VOGTLE ELECTRIC GENERATING PLANT, UNIT 1

AMENDMENT TO FACILITY OPERATING LICENSE

Amendment No. 50 License No. NPF-68

Amendment No. 29 License No. NPF-81

FIGURE 3.4-4b

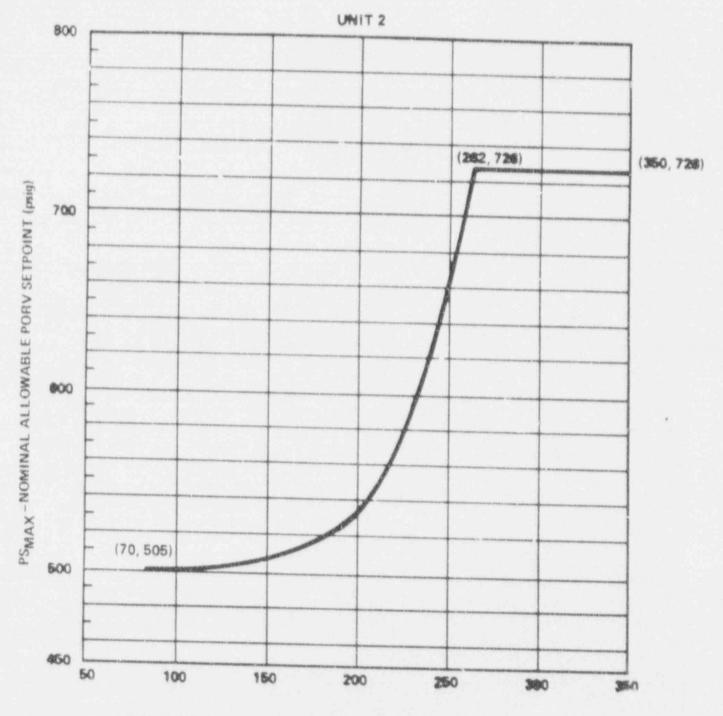
Replace the following pages of the Appendix "A" Technical Specifications with the enclosed pages. The revised pages are identified by Amendment number and contain vertical lines indicating the areas of change.

UNIT 2 MAXIMUM ALLOWABLE NOMINAL PORV SETPOINT FOR THE COLD OVERPRESSURE PROTECTION SYSTEM
